(COUNTY PLAN NO. SP-37-99, BMP ID NO. YC 014)

POND RECORD DRAWING
WYTHE CANDY & GOURMET SHOP
WAREHOUSE ADDITION
JAMES CITY COUNTY, VIRGINIA

Date: April 12, 2001
To: OK James Construction; DJG, Inc.
From: Scott J. Thomas, P.E. *SJT*
Subject: Wythe Candy Warehouse (County Plan SP-37-99)
County BMP ID Code: YC 014

Re: Wythe Candy Warehouse Addition (County Plan No. SP-37-99)
6623 Richmond Road
Stormwater Management/BMP Facility (YC 014)

EMERGENCY SPILLWAY
NOT TO SCALE

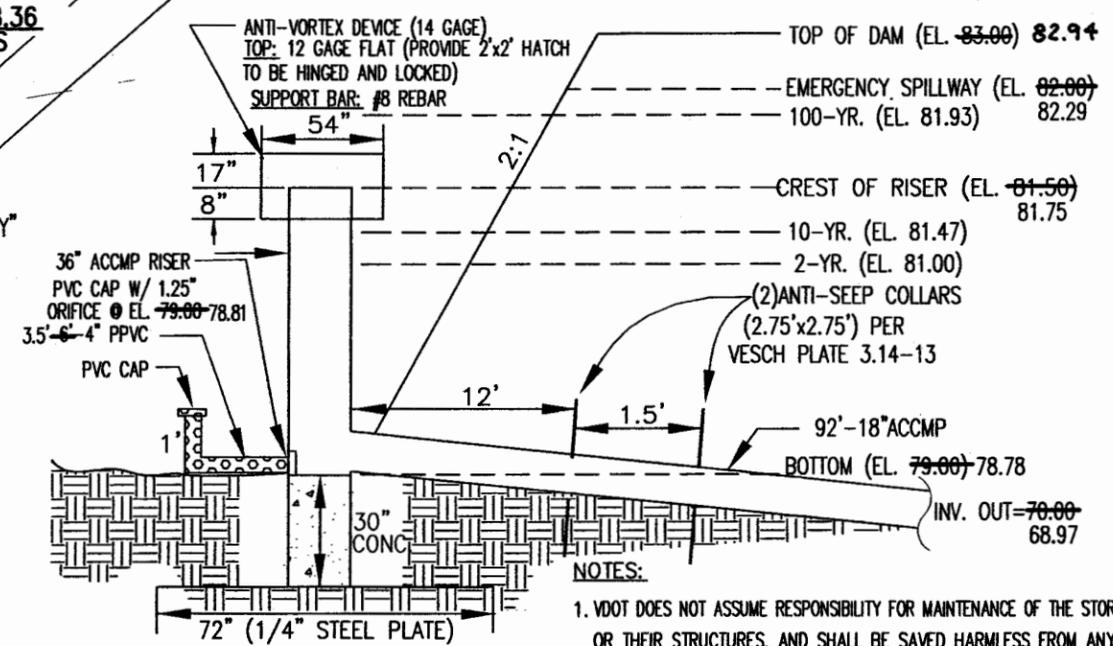
NOTE: TWO ROCK CHECK DAMS ARE ~~TO BE~~ ^{33'} ~~15'~~ ^{TO 20'} APART IN THE EXISTING OUTFALL CHANNEL. IN ADDITION, THE LAST 15' OF THE CHANNEL WHERE IT CONNECTS TO THE LARGER CHANNEL ^{IS} ~~NEEDS TO BE~~ RIPRAP LINED TO PROTECT THE EXISTING SEWER LINE BENEATH THE CHANNEL.

2. Show the following additional information on the record drawing: constructed dimensions for the emergency spillway including bottom width and lined depth; and provide additional spot elevations at the downstream (south) side of the fill embankment slope or toe as required to reflect the constructed downstream embankment slope.
3. A professional seal is required on the record drawing.
4. If possible add the following County identifiers to the lower right hand corner of the record drawing: County Plan Number SP-37-99 and BMP ID No. YC 014.

- ✓ Show the following additional information on the record drawing: constructed dimensions for the emergency spillway including bottom width and lined depth; and provide additional spot elevations at the downstream (south) side of the fill embankment slope or toe as required to reflect the constructed downstream embankment slope.
 - *DIMENSIONS OF THE EMERGENCY SPILLWAY ARE PROVIDED ON DETAIL. SPOT ELEVATION ADDED TO THE DOWNSTREAM SIDE OF FILL EMBANKMENT AS REQUESTED.*
- ✓ A professional seal is required on the record drawing.
 - *SEAL PROVIDED AS REQUESTED.*
- ✓ If possible add the following County identifiers to the lower right hand corner of the record drawing: County Plan Number SP-37-99 and BMP ID No. YC 014.
 - *IDENTIFIERS PROVIDED AT THE LOWER RIGHT HAND CORNER OF THE DRAWING AS REQUESTED.*

POND RECORD DRAWING
WYTHE CANDY & GOURMET SHOP
WAREHOUSE ADDITION

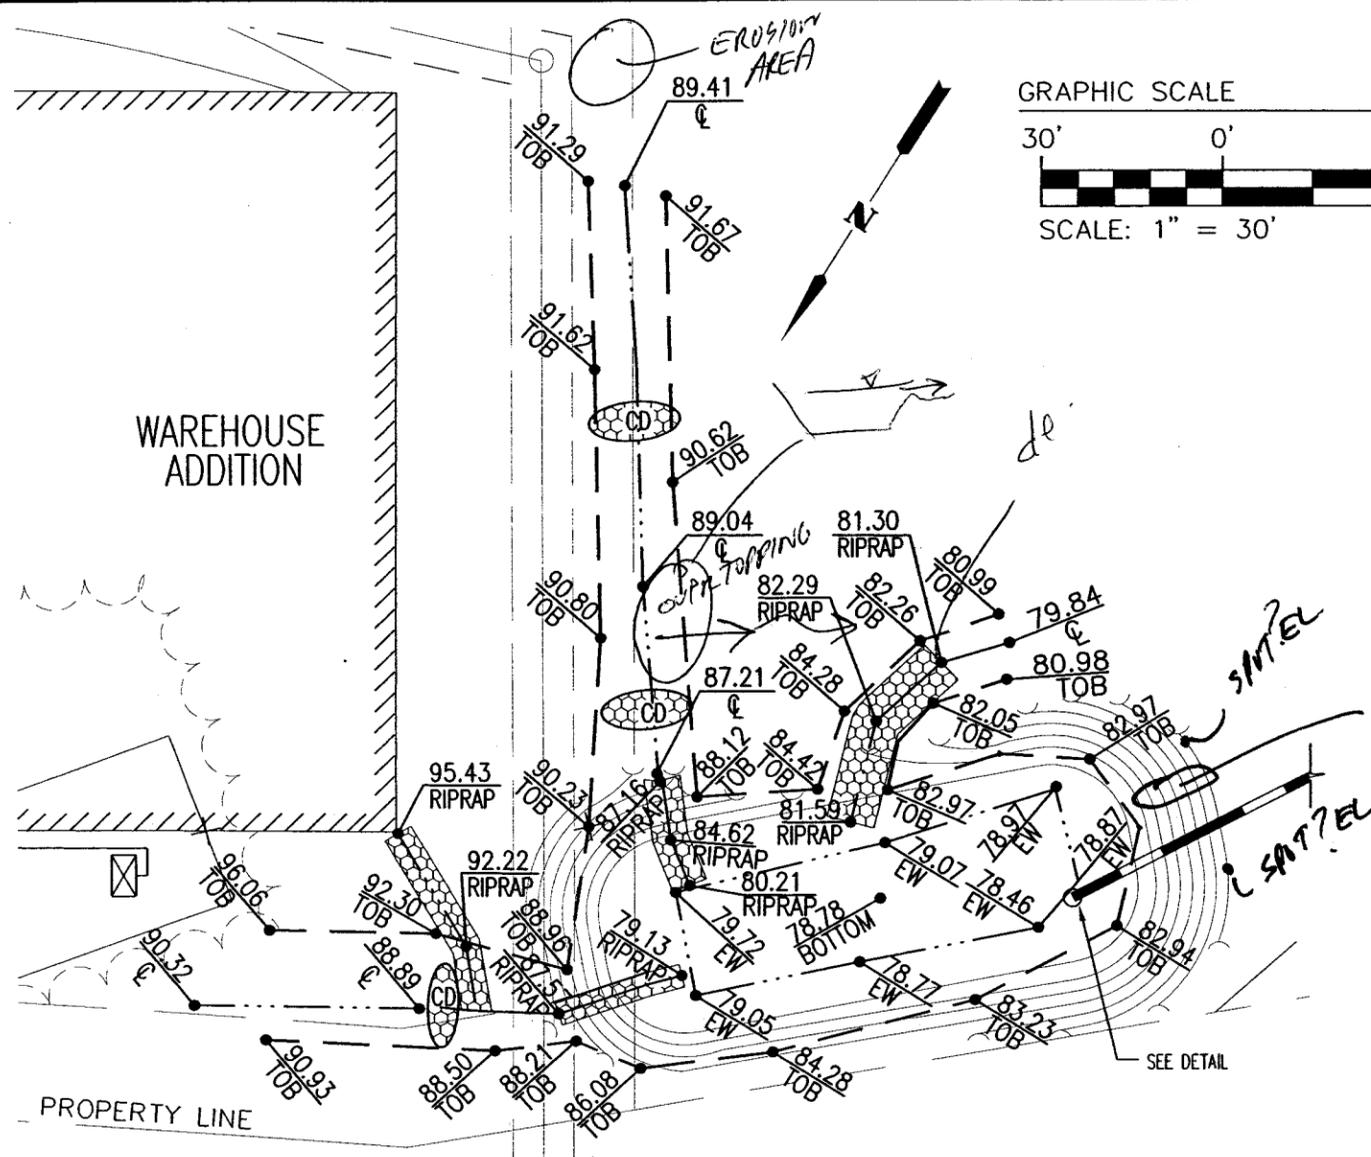
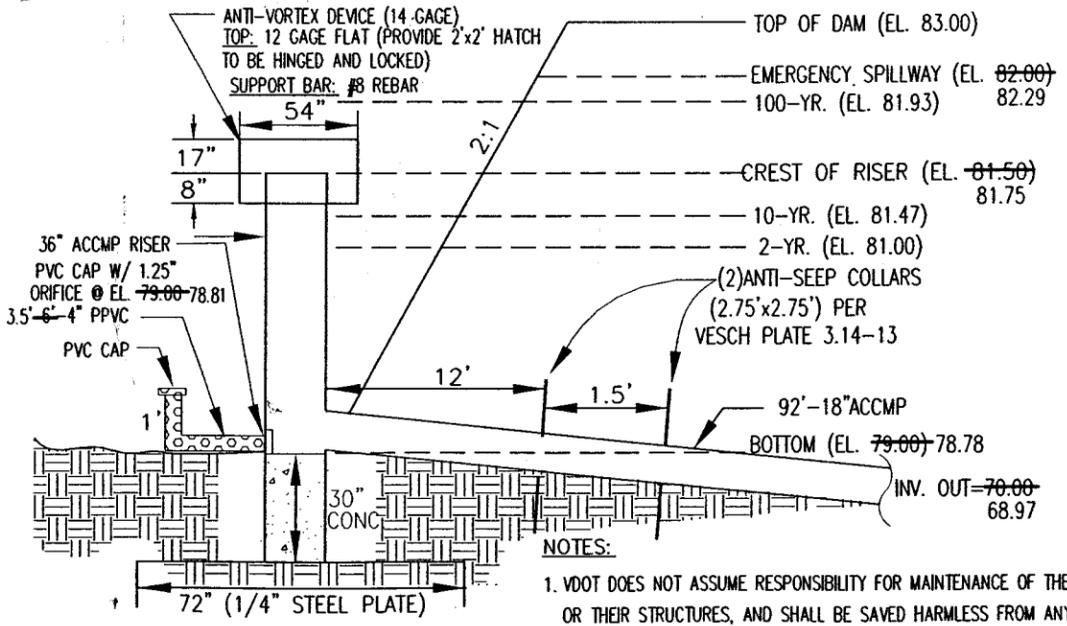
The Environmental Division has reviewed a record drawing as submitted to our office on October 6th for the above referenced project. The record drawing provides as-built information for a stormwater management/BMP dry detention facility and its associated stormwater conveyance channel systems as located in the southwest corner of the site.

Based on our review of the drawing and a concurrent field observation, the following items must be addressed prior to release of the developer's surety instrument for the stormwater management/BMP facility:

PLAN
SCALE: 1"=50'

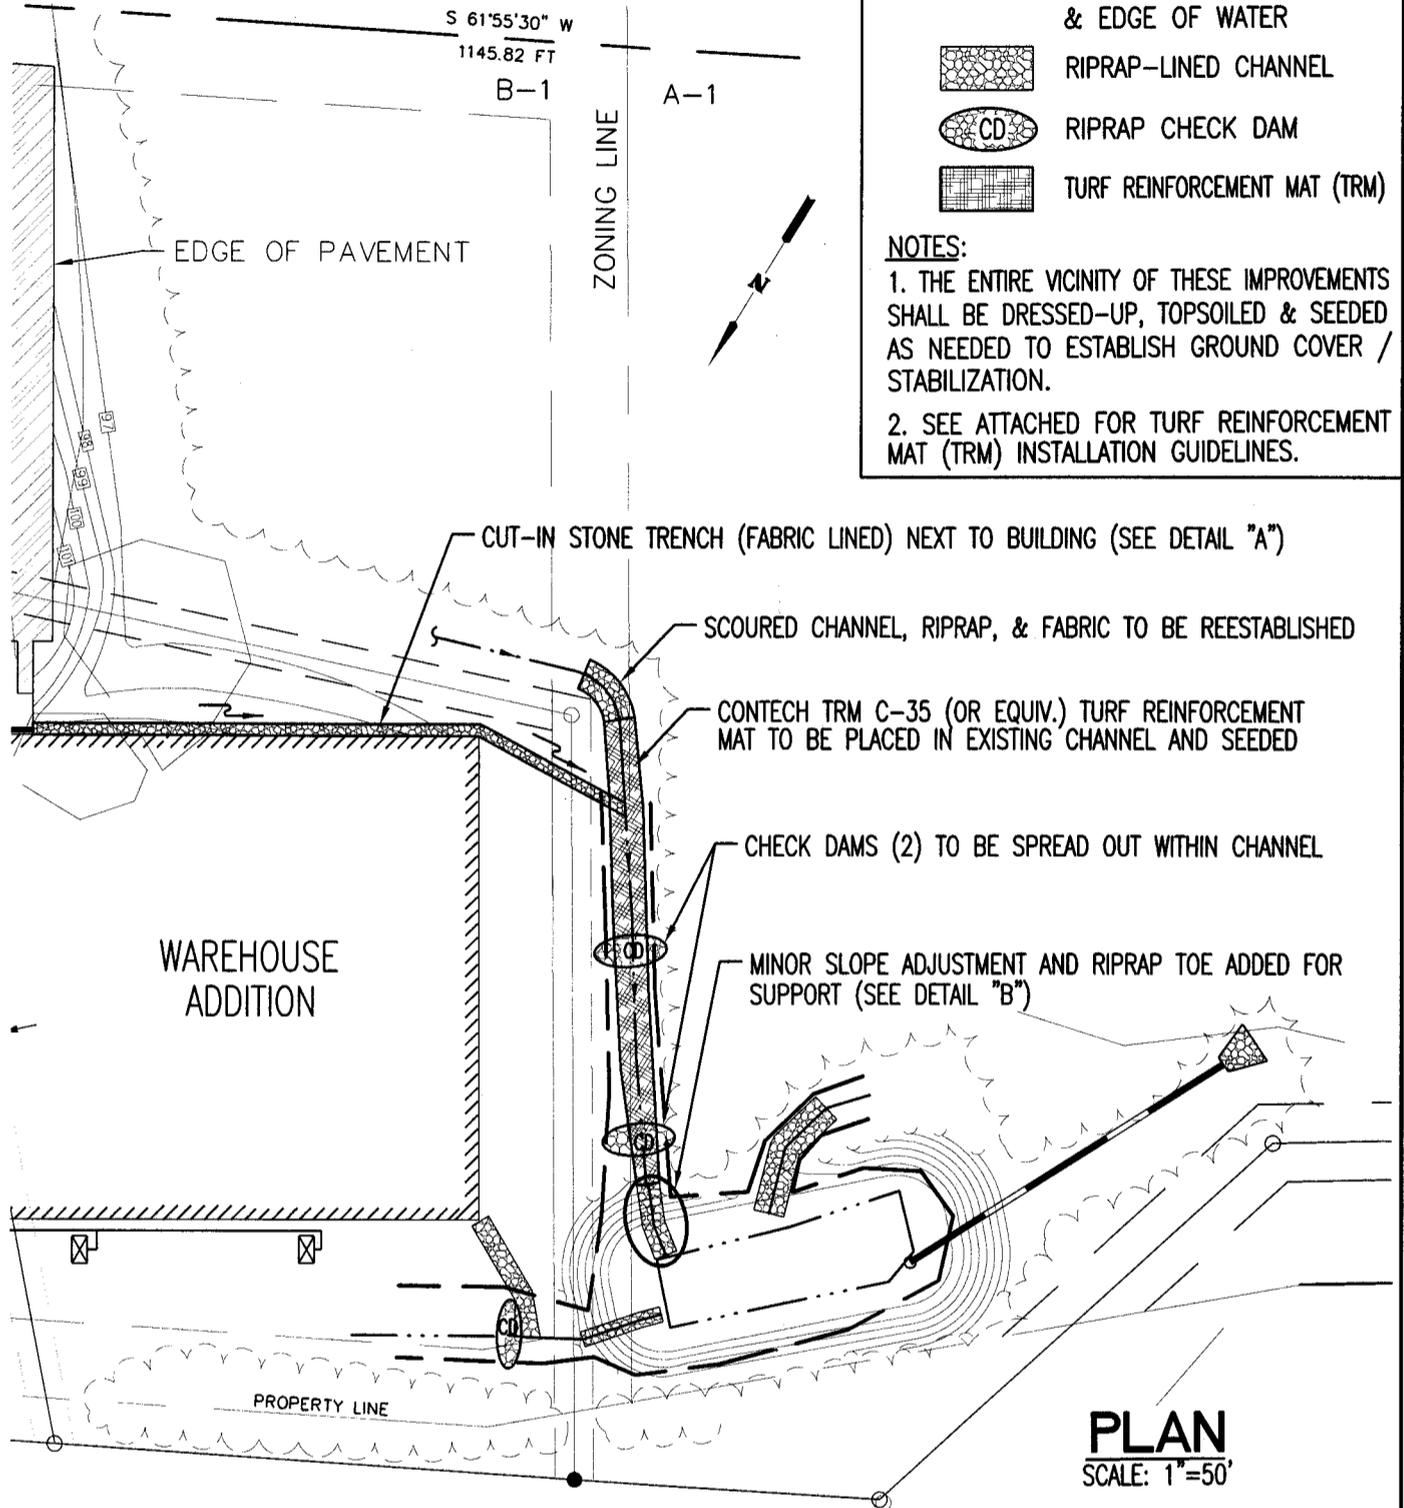
- 1a) Channel berm failure and deep scour hole.
- 2a) Perimeter bare soil areas needed stabilized with seed & mulch.
- 3a) Removal of vegetated growth within 15 feet of BMP riser.
- 4a) Remove site erosion & sediment control measures (silt fence, etc.)

Based on a review of the approved plans and computations for the project, there appeared to be no formal design section for the south channel to ensure erosion resistance of the steeper channel segment (through the curve) and to ensure adequate capacity at the flatter portion. Approved plan SP-37-99 called for the contractor to provide for positive drainage to pond through the swale. There was no typical design section shown on the plan and no formal design to provide a stormwater conveyance channel and diversion dike of adequate bottom width, side slope, channel depth, freeboard or lining.

1. THE ENTIRE VICINITY OF THESE IMPROVEMENTS SHALL BE DRESSED-UP, TOPSOILED & SEEDED AS NEEDED TO ESTABLISH GROUND COVER / STABILIZATION.
2. SEE ATTACHED FOR TURF REINFORCEMENT MAT (TRM) INSTALLATION GUIDELINES.
